# Access Compliance Report

## Public Rights-of-Way

Intersection ID: 43842	Main Street: BRADSTREET_COMMONS_WY	Cross Street: DELUCA_DR	Location: SW
ADA ID: D051EA34B1DE	Ramp Type: Perp	Initial Pass/Fail: Fail	Overall Compliance: No
		Severity Score: 8.75	
Codes/Mitigation Info/Possible Solution		Field Measurements/Component Compliance

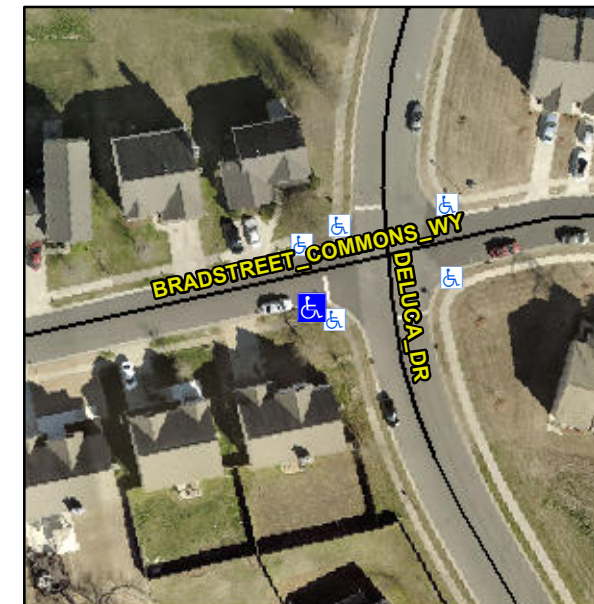
**Remove & Replace Entire Ramp.**

**Not Found, R304.5.1**
